SAFETY RECALL

Sr05-06A

SUBJECT: IMPROPER MOUNTING OF 3 RADIUS ROD

REVISION: A

FIGURE 3: REAR SUSPENSION

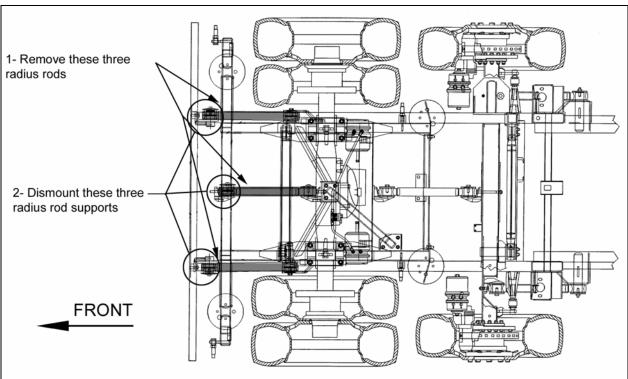
- 5. Dismount successively the 3 radius rods identified in figure 3 by flattening the tabs of locking plate and by unscrewing the two bolts directly fastened into radius rod pivot (if needed, refer to maintenance manual).

- 6. Dismount successively the 3 radius rod supports identified in figure 3. Take note of the position and quantity of shims in order to reinstall the components in the same condition as they were to maintain proper vehicle alignment.

FIGURE 4: SUPPORT CLEANING (typ. 3 supports)

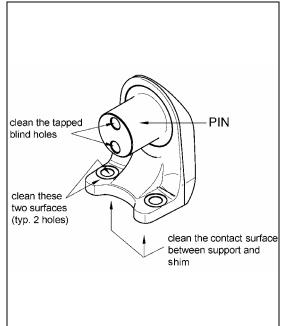
- 7. Using brake cleaner, thoroughly clean the 3 supports contact surfaces to remove all trace of antiseize compound. Clean the contact surfaces between support, shim and structure. On supports (see figure 4), clean the contact surface of the bolt head, the passing holes and use brush #684901 to clean the tapped blind holes. Use brake cleaner and a clean clothe to dry.

FIGURE 5: CLEANING OF 2 PINS AND THE CENTRAL SUPPORT PIN

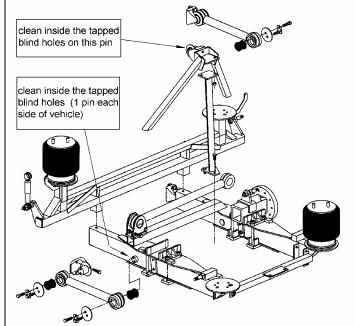
- 8. Clean inside the 6 tapped blind holes where the supports are bolted. Use brake cleaner, brush #684901 and a clean clothe to dry.
- 9. Clean inside the tapped blind holes of the 3 support pins identified in figure 5. Use brake cleaner, brush #684901 and a clean clothe to dry.

FIGURE 6: REAR SUSPENSION

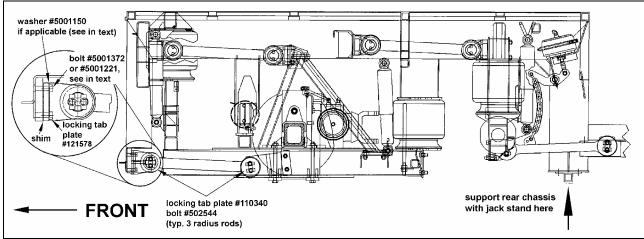
- 10. Reinstall the supports (figure 6). Do not forget to reinstall the shims correctly.
 - Use 2 new bolts (#5001372) per support. If your vehicle is included in the range beginning from 2PCW33494<u>5</u>102<u>8407</u> up to 2PCW3349X<u>5</u>102<u>8461</u> inclusively, you must use bolts #5001224 instead.
 - Use new tab locking plates (Prevost #121578).
 - For the outer left and right supports, you <u>must</u> use new washer (#5001150) if the total thickness of their respective shims is less than 1/8" (3mm).
 - Put 3 drops of Loctite 243 (Prevost #680038) in each of the 6 tapped blind holes and a line of Loctite on bolts.
 - Tighten bolts to a torque of 185-205 lbf-ft.
- 11. Fold locking tab over bolt heads.
